FINAL PLAT

~~BROCK~~ BROCK FOURTH ADDITION

Re: S/D 97-23 - BROCK 4TH ADDITION (Final Plat)

STAFF REPORT
(Final Plat, Approved 4/3/97)

FINAL PLAT

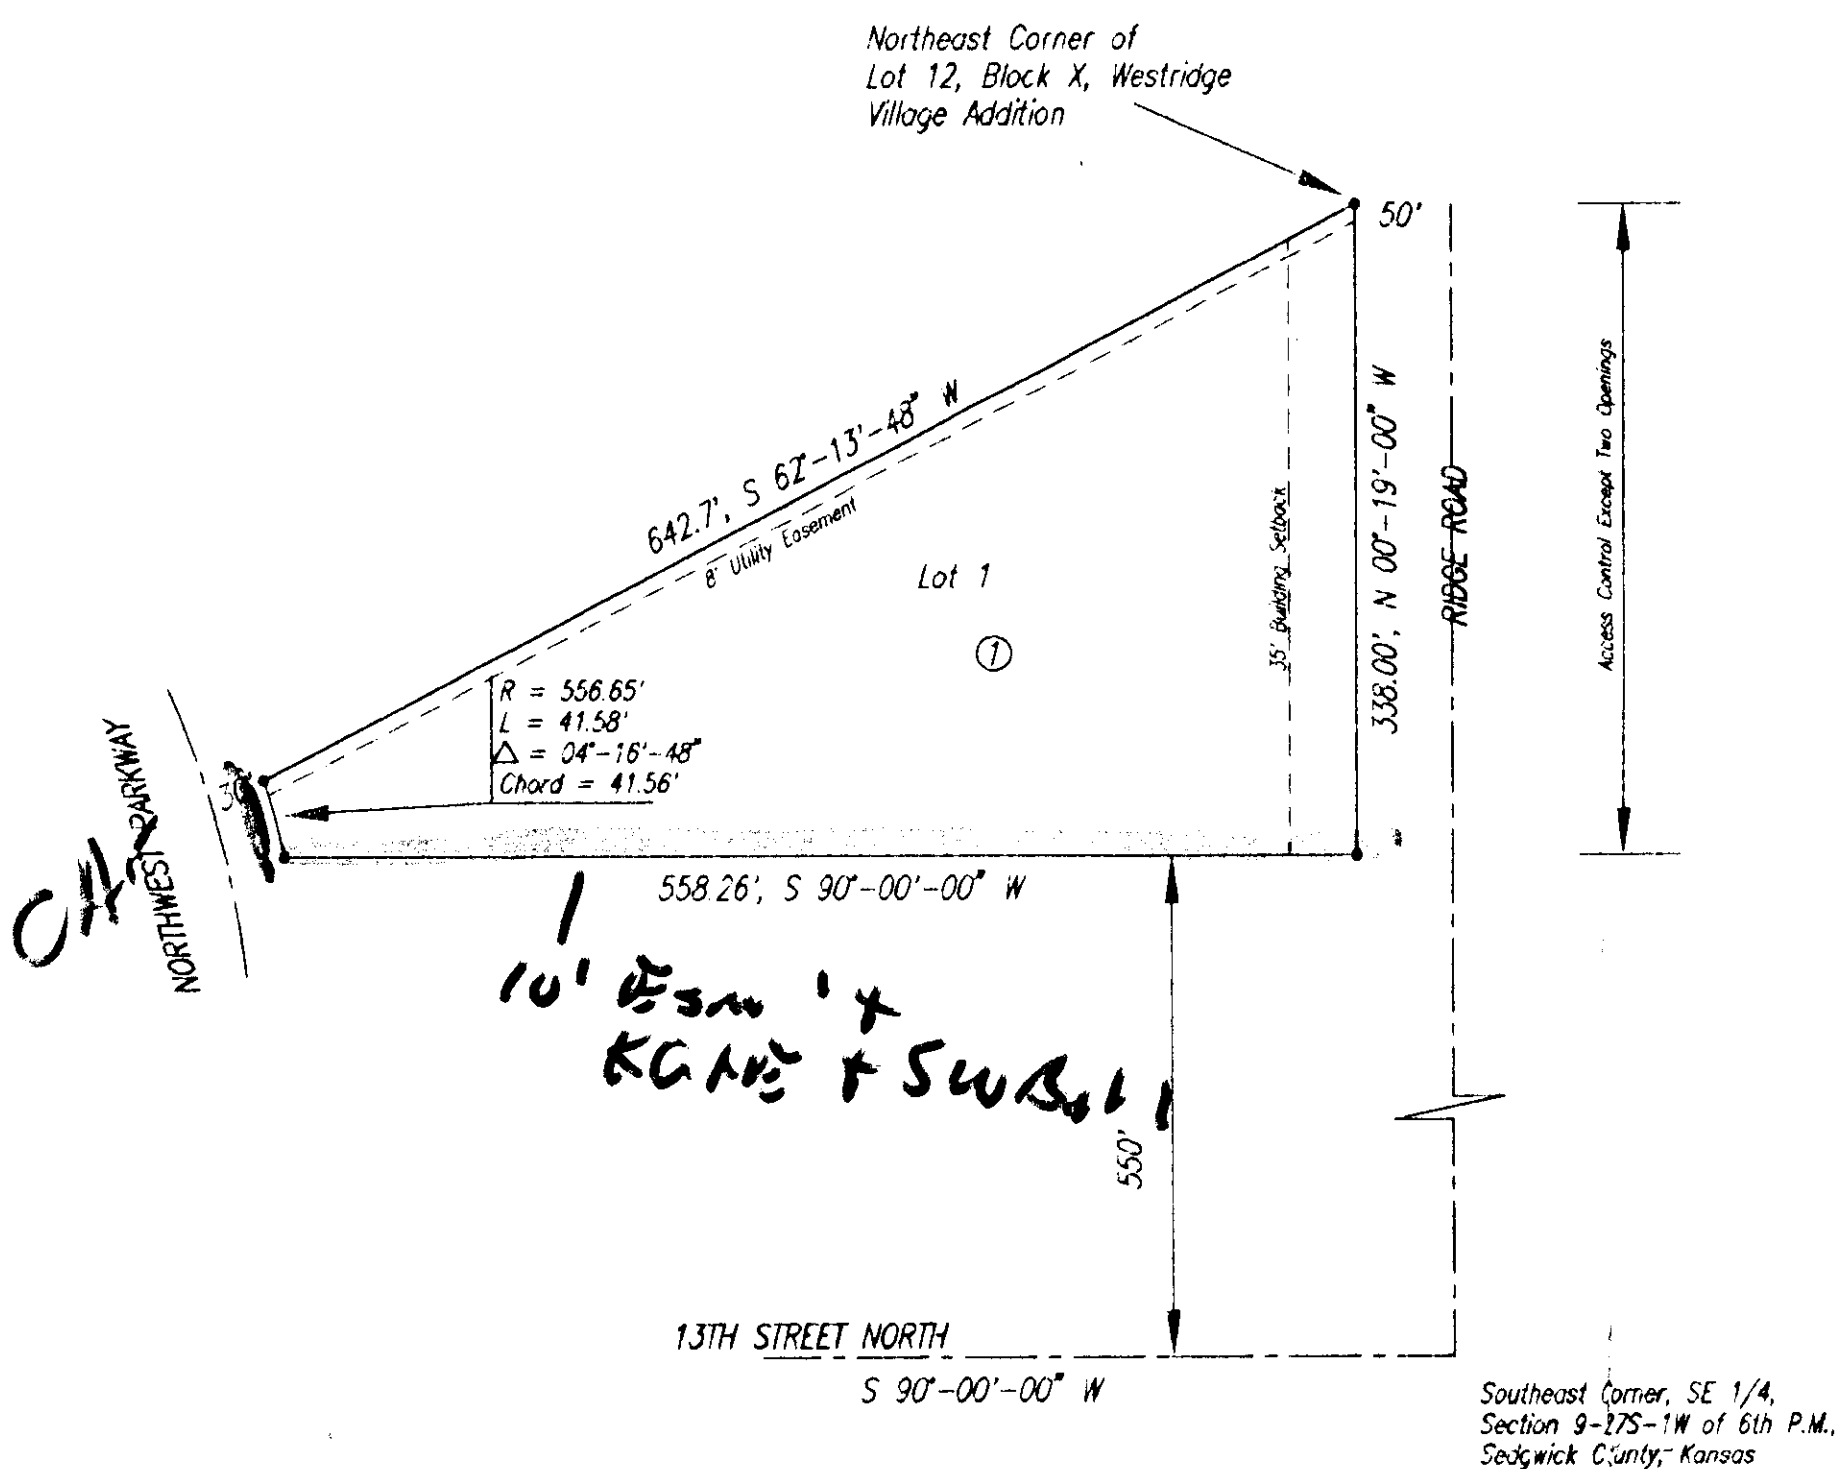
- C. On the final plat tracing, complete access control shall be shown to Northwest Parkway. Also, only one access opening shall be indicated to Ridge Road. Both the face of the plat and platter's text shall note this access control. The platter's text shall also be amended to use the standard terminology for the dedication of access controls to the City of Wichita and that the location of any opening (to Ridge) is subject to approval by the City Engineer.

- D. On the final plat tracing, the Deputy Register of Deeds shall be indicated as Michael D. Hurtt.
- E. If the dot symbols at the corner of this plat (lot) involve irons found, set, etc. this should be noted in a legend located below the north arrow.

- F. On the final plat tracing, the center line of Ridge shall be labelled "CL".
- G. The applicant shall install or guarantee the installation of all utilities and facilities which are applicable and described in Article 8 of the MAPC Subdivision Regulations. (Water service and fire hydrants required by Article 8 for fire protection shall be as per the direction and approval of the Chief of the Fire Department.)

- L. The final plat shall indicate the utility easements requested by K.G. & E. and Southwestern Bell which are indicated on the enclosed "marked" copy of the plat.

- M. As requested by the applicant, the final tracing may be submitted with a revised name. It should be noted that an Addition, now within Wichita, exists with the name Winter. While the use of Winters should be acceptable, it is recommended that a greater name distinction be used such as by adding a first initial, e.g., A. Winters, T. Winters, or so forth.
